CITY OF CODY  
PLANNING, ZONING AND ADJUSTMENT BOARD  
TUESDAY, OCTOBER 28, 2014  
CITY HALL COUNCIL CHAMBERS

**CITY OF CODY  
PLANNING, ZONING AND ADJUSTMENT BOARD  
STAFF REPORT**

<b>MEETING DATE:</b>	OCTOBER 28, 2014	<b>TYPE OF ACTION NEEDED</b>	
<b>AGENDA ITEM:</b>		P&Z BOARD APPROVAL:	X
<b>SUBJECT:</b>	SITE PLAN REVIEW: NEW WHITLOCK MOTORS SITE. SPR 2014-38	RECOMMENDATION TO COUNCIL:	
<b>PREPARED BY:</b>	TODD STOWELL, CITY PLANNER	DISCUSSION ONLY:

<b>MEETING DATE:</b>	OCTOBER 28, 2014	<b>TYPE OF ACTION NEEDED</b>	
<b>AGENDA ITEM:</b>		P&Z BOARD APPROVAL:	X
<b>SUBJECT:</b>	SITE PLAN REVIEW: AUTOZONE SPR 2014-23	RECOMMENDATION TO COUNCIL:	
<b>PREPARED BY:</b>	TODD STOWELL, CITY PLANNER	DISCUSSION ONLY:

**A1.0**  
 SHEET #  
 1 OF

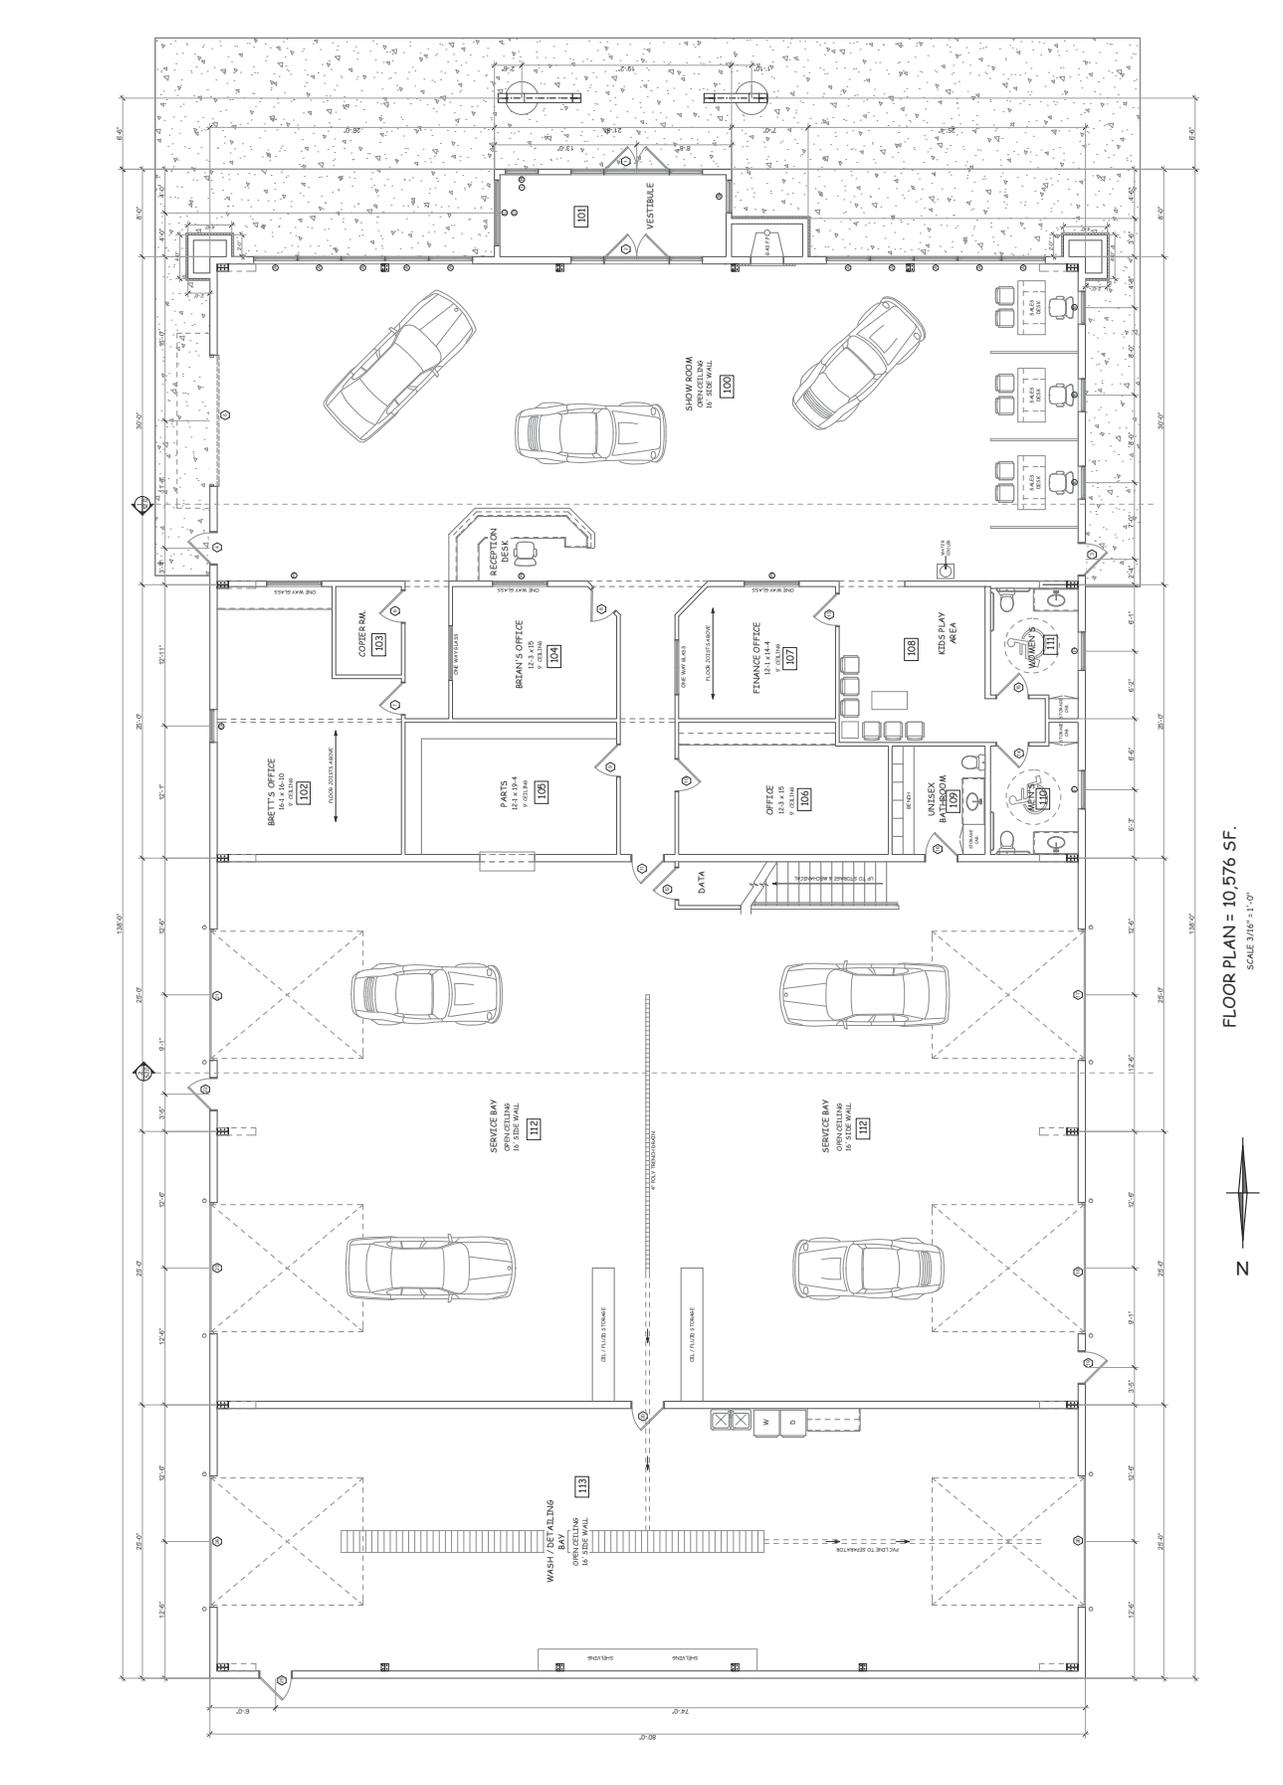
The exterior lighting plan for the building is shown on the electrical plan (Sheet E1.0). The primary lighting for the building exterior includes full cutoff LED wall packs mounted on the north, east and west sides of the building. The front of the building has extensive lighting using full cut-off fixtures.

While a full photometric plan has not been submitted, the lighting cut sheets (specifications) seem to indicate that due to distance to property lines, there will not be significant amounts of lighting from these wall packs extending beyond the property line. Furthermore, there do not appear to be any immediately neighboring land uses that would be sensitive to minimal lighting impacts. The condo units to the south are about 240 feet away.

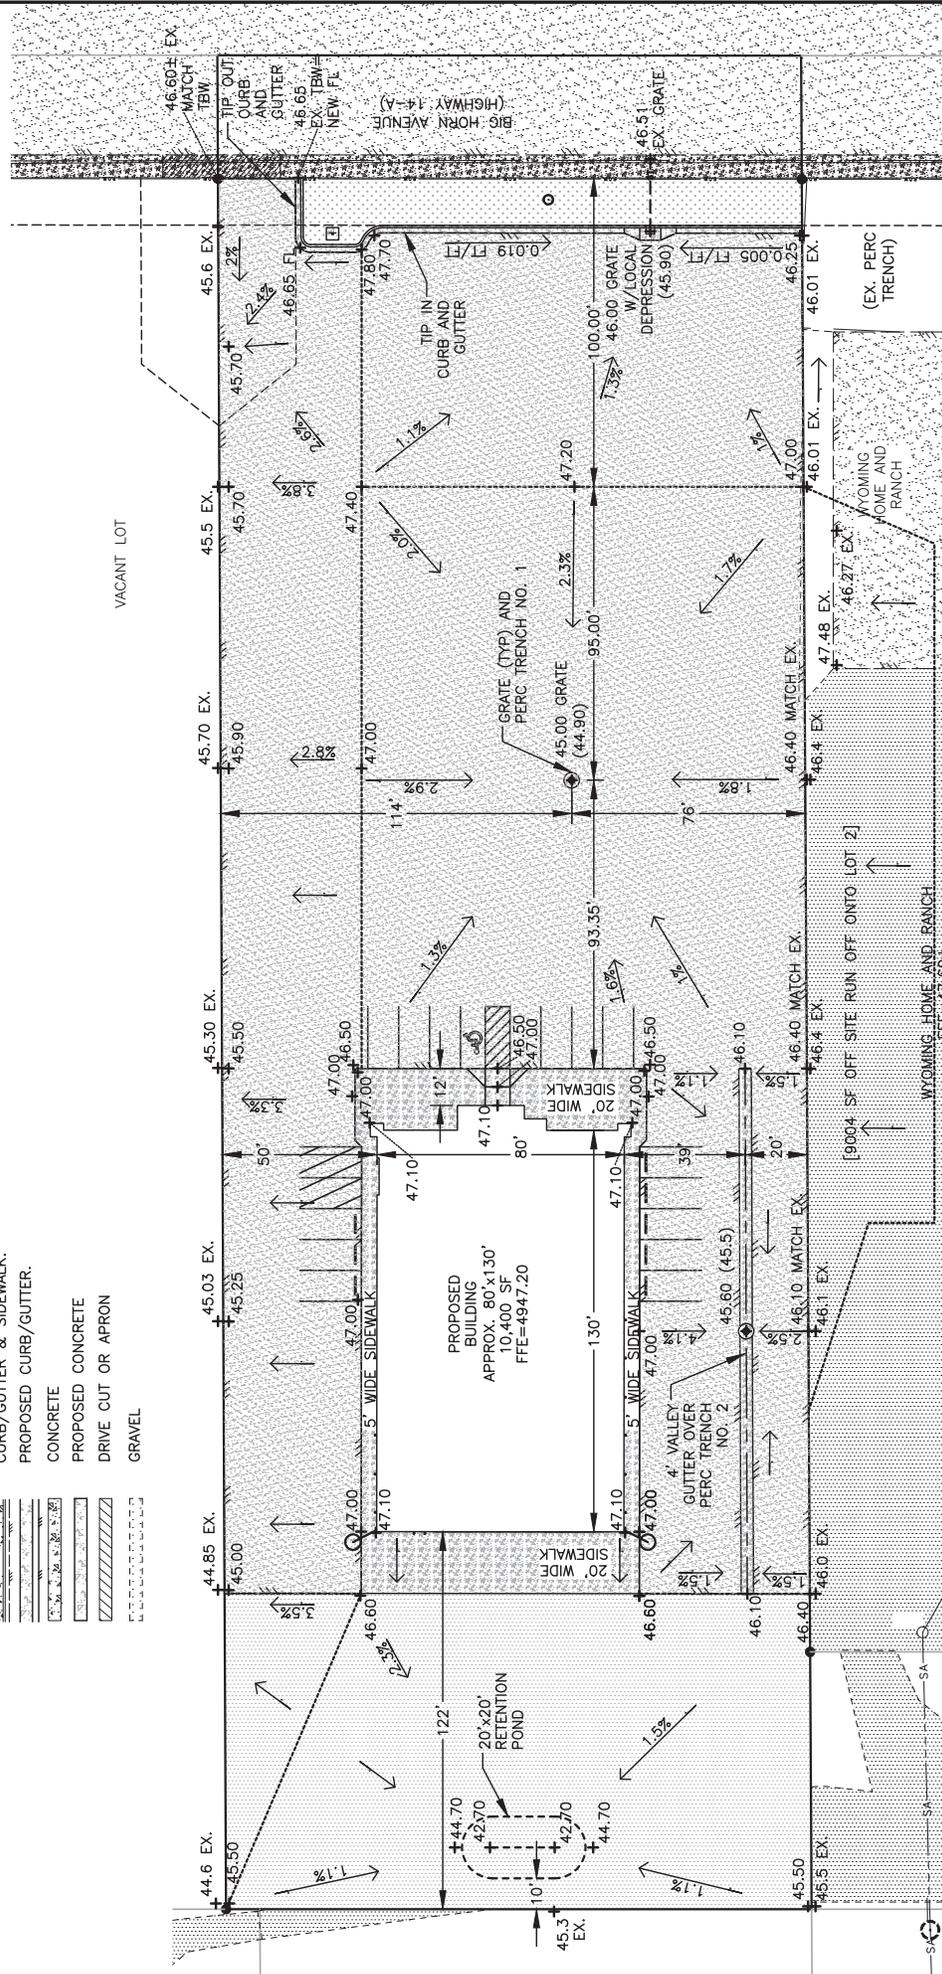
The proposed landscaping is shown on the site plan. It includes irrigated grass lawn along the frontage for a depth of fifteen feet, plus an additional island extension around the future freestanding sign. While lawn is often the Board's preferred groundcover, a lack of vertical components in the landscaping has been a concern in the past. Groupings of shrubs or large boulders in conjunction with the lawn would enhance the landscaping and provide the vertical component currently lacking. Due to utility easements, trees are not an option in the first 15 feet next to the highway. For a 600-foot deep property on one of the City's main entry corridors, the amount of landscaping proposed is relatively minimal.

Access to and from the site is through an existing shared approach to Big Horn Avenue. All but the landscape area and the area at the back of the property will be paved with asphalt or concrete. The boundaries of the vehicle display area are not identified on the site plan, which is not of great concern provided a clear access route, at least 20

feet wide and maneuverable by emergency vehicles, is always available to the building. Due to multiple possible routes, the route was not required to be shown on the site plan. It is also noted that a minimum 24-foot backup area/parking lot aisle needs to be left clear behind all parking spaces.

The primary parking areas will provide 16 paved spaces. Additional gravel parking is available to the rear of the building—primarily for vehicles using the service shop. The paved spaces and gravel area provide for more than the 27 spaces required based on 1 space per 300 sq. ft. for the office and indoor sales area, plus 3 spaces per service bay. It is noted that the gravel parking area will be unmarked, as it is expected to be used primarily by employees and in conjunction with the service shop.

The driveways and parking spaces meet the dimensional requirements of the parking ordinance. Other parking requirements, including illumination, surfacing, proximity to building, configuration, pedestrian access to building, circulation patterns, etc. are met. A stop sign at the exit should be added to the site plan. The location needs to be carefully coordinated with Public Works to avoid the utilities in the utility easement along the front of the property.

The building will utilize domestic water, power, gas, and sewer service, as shown on the site plan. The locations of the service lines are acceptable, but some of the details are lacking or need corrected. These details can be addressed in conjunction with the building permit review and generally relate to the sizes and configuration of the water lines, backflow preventer, meters, tapping method, etc.

1. A stop sign is to be installed at the exit, in accordance with City standards.
2. Provide corrected utility details on the plan set that will be submitted with the building permit. The details are to be per the utility provider's requirements. Include a reduced pressure principle backflow preventer on the water line.
3. The light poles are limited to \_\_\_ (32?) feet above grade.
4. Provide an update to the storm water inlet detail, which shows a type of pipe approved by the city and WYDOT. An encroachment permit for the work must be obtained prior to installation.
5. Add the "Van Accessible" sign to the ADA parking sign.
6. Applicable city utility fees (water, sewer, power) are to be paid prior to building permit issuance.
7. The project must otherwise comply with the site plan and applicable building, fire, and electrical codes.

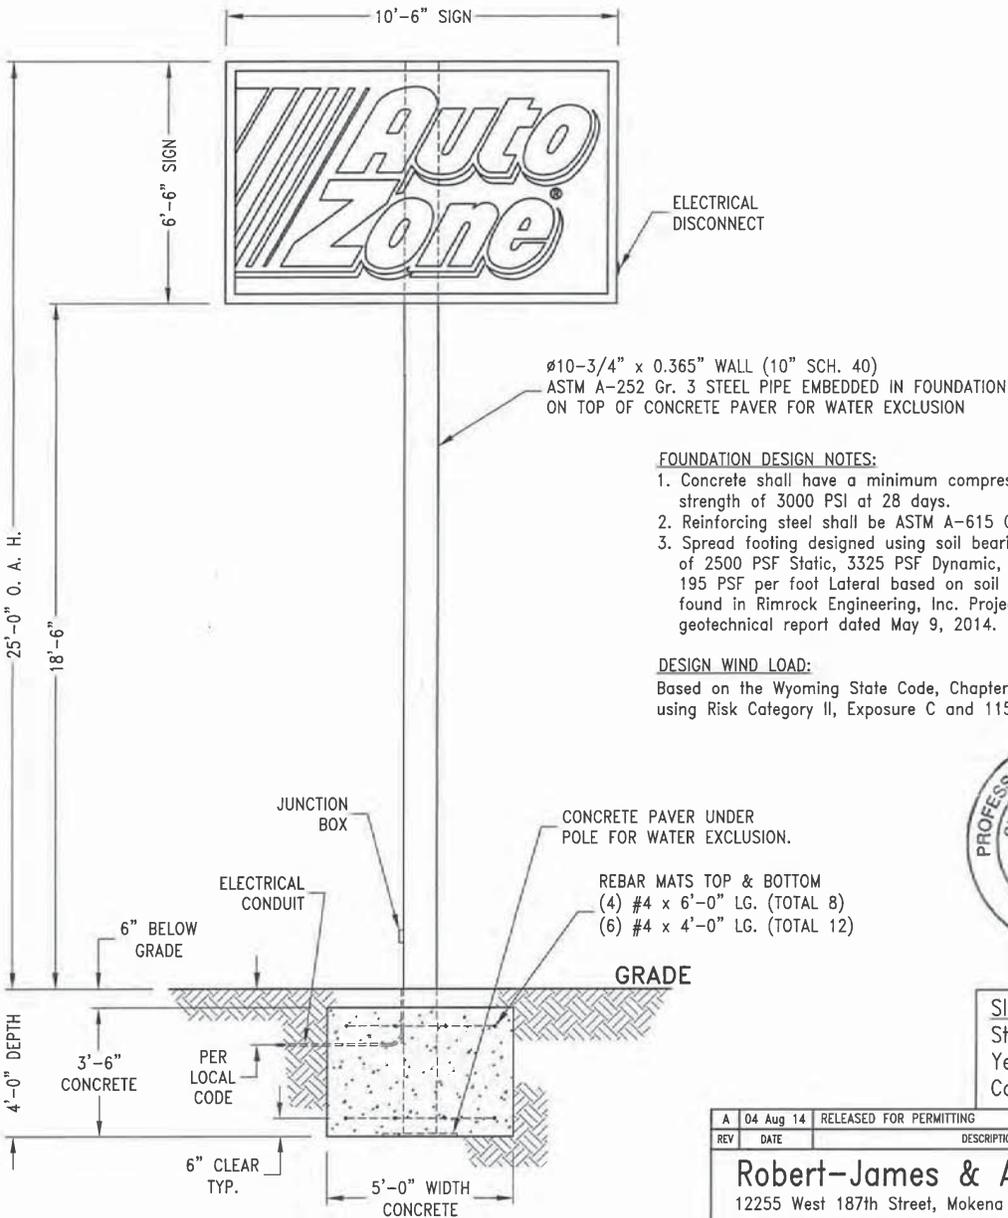
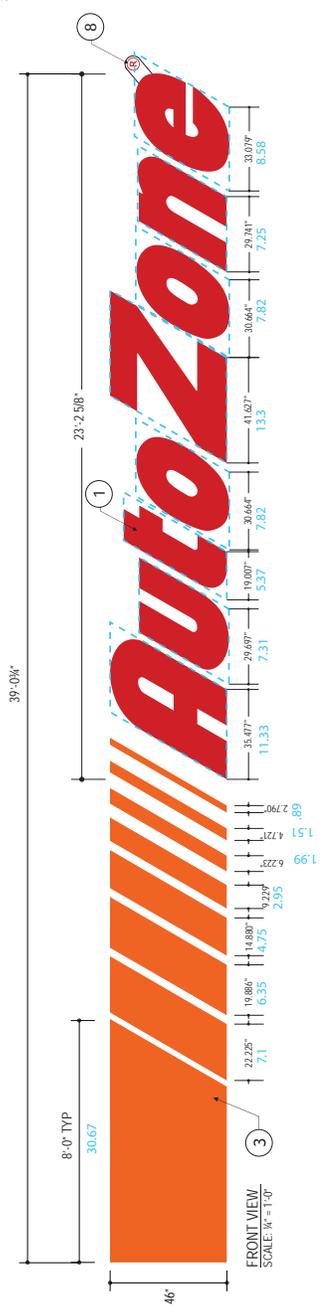
A photometric plan is included and demonstrates that lighting will be largely contained within the site. The light fixtures on the light poles will apparently be at a height of 28 feet (Have applicant clarify—Sheet C1.A Figure 13 shows 25' pole on 3' base, while the photometric plan PH1.0 shows a 28' pole on a 3' base). The fixtures are 209 watt LED fixtures.

**1 ELECTRICAL SITE PLAN**  
SCALE: 1" = 30'

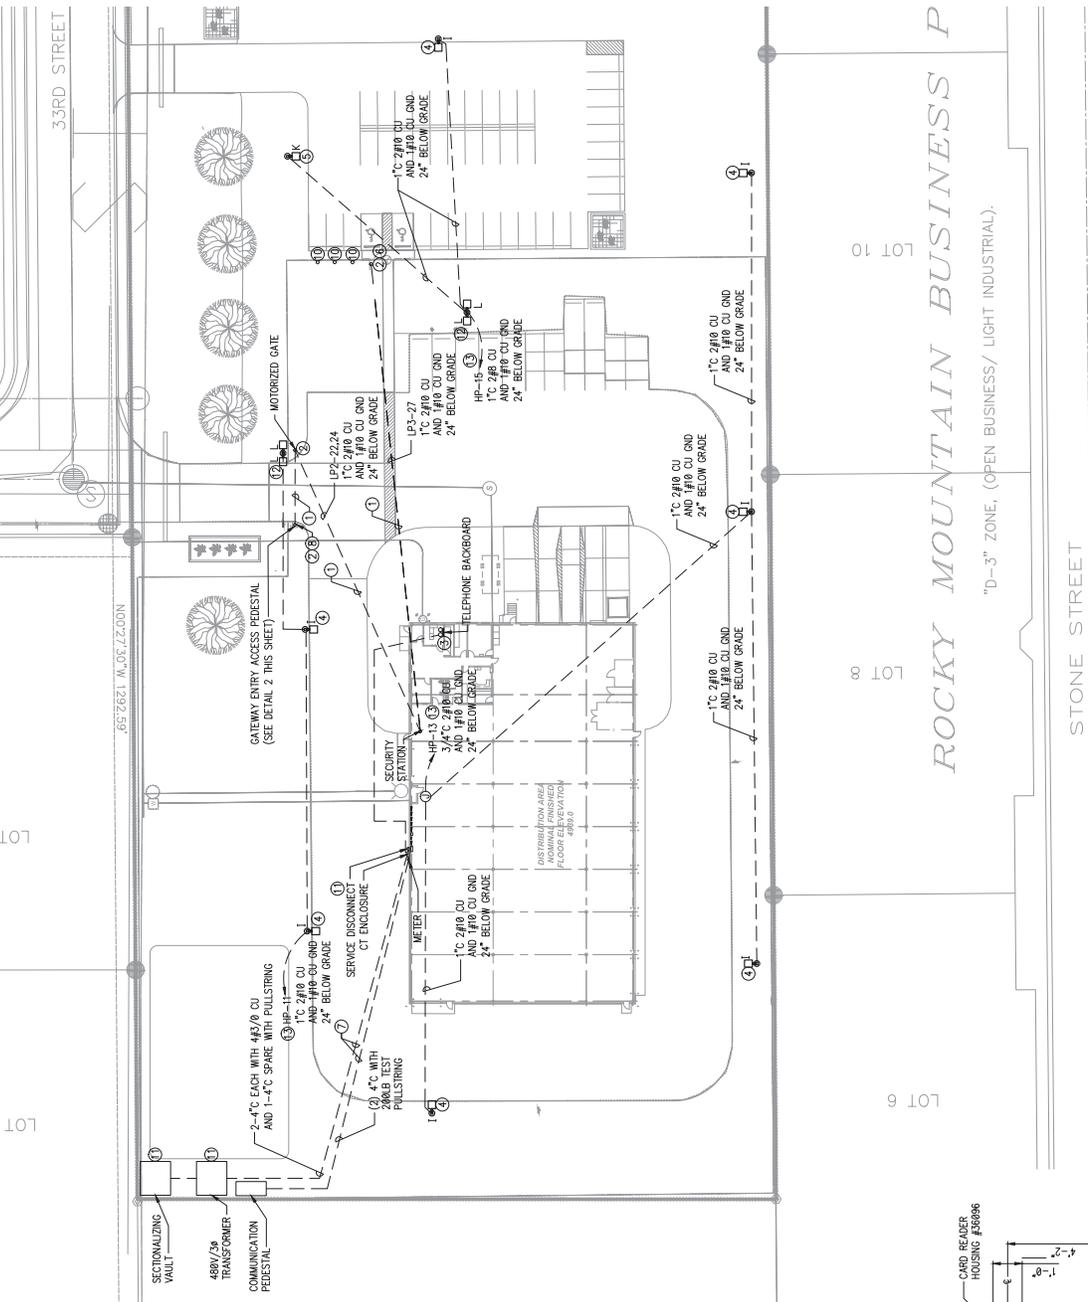
The building will utilize domestic water, power, gas, and sewer service. The water and sewer details on the "Treated Water and Sewer Main Extensions" plan reflect the current proposal (Modifies Sheet C-02). As these plans were just received, Public Works has not had a chance to review them. Conceptually they look like what Public Works was asking for, with the exception of missing a fire hydrant on the water line.

The proposed wall sign is a 30" by 71" non-illuminated panel displaying "FedEx Ground", at the southeast corner of the building. An entry sign at the truck entry would be a five-foot tall, 3-foot by 5-foot address sign (Note 9 on Sheet C-01). Other signs noted on Sheet C-01 are on-site "convenience" signs. All of these signs can be authorized as proposed.
